Ada Township Parks & Recreation
7330 Thornapple River Drive
Ada, Michigan 40301
Site Accessibility Report

Prepared by Disability Advocates of Kent County

May 15, 2017

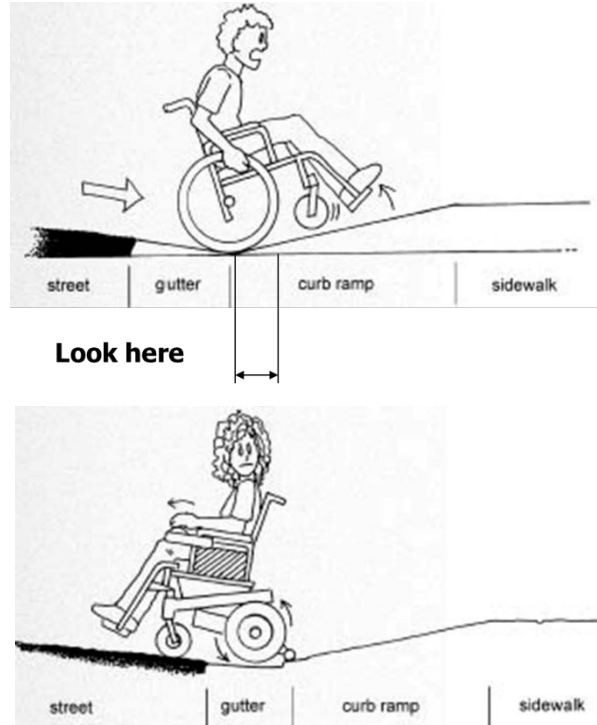
- **The E.E Locke Arboretum Gazebo & The Ponds Gazebo:** The Arboretum and Ponds Gazebo each have a grill station for guest's use. However the grill stations are located away from the stable and level surface of the Gazebo floor. The Gazebos are a main feature of the park and the adjacent grill should be made accessible. As the Gazebos are primarily wood, the grills cannot be moved to be directly adjacent to the structure. However a concrete or asphalt pad should be added that directly connects with the wooden floor of the Gazebo (**Level 3 recommendation**). The grill station cooking surface is over 36-inches above the ground. This may be a barrier to guests who use assistive technology such as wheelchairs or scooters, and who may not be able to use a cooking surface that is so far off the ground, or who are unable to safely use the station with the flame element so close to the face. The grill station cooking surface should be lowered so that it not higher than 36-inches above the ground (**Level 2 recommendation**).

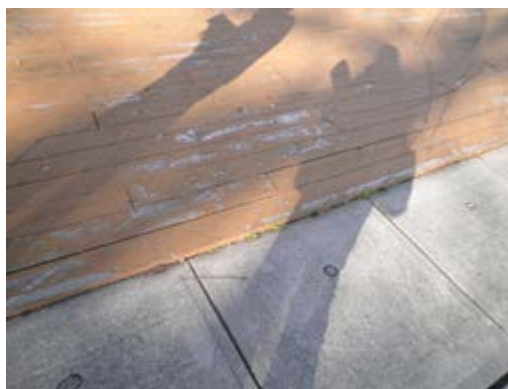
- The Parking Lot:** The parking lot is in excellent condition. However, the curb ramp located near the designated accessible parking spaces is a barrier. The ramp slope is ADA compliant. The Ramp-Gutter Transition, or the section of the ramp nearest the Gutter, is significantly steeper. This may make it difficult to impossible to use the ramp while using certain models of assistive technology. Requiring guests to use the curb ramps at the other ends of the parking lot is not acceptable. One way to

comply with the ADA is to move the accessible parking spaces to a different curb ramp. However, the current placement of accessible parking spaces is optimal, and allows for people with mobility related disabilities to exit a vehicle and be near to many different park attractions. By moving the parking spaces to different locations, the access to some features may be reduced due to increased distances. For instance, if the two spaces were moved towards the Ball Diamond Overlook, people with limited stamina or mobility would be discouraged from visiting the Covered Bridge and River Overlooks. Alternatively, by moving the accessible parking spaces to the curb ramp nearest the Covered Bridge, these same guests would be discouraged from visiting the Ball Diamond Overlook. To comply with the ADA, the current curb ramp near the designated parking spaces should be renovated to have a shallower ramp-gutter transition.

This may be accomplished by grinding down the concrete transition to make the slope less steep (**Level 2 recommendation**). This may also be accomplished by adding concrete to the transition so that it extends into the gutter further than it currently does. By making the transition longer, the slope will be reduced (**Level 2 recommendation, see right**). The transition extension should be stable and no uplifting should be present. The ramp should smoothly connect to this extension.
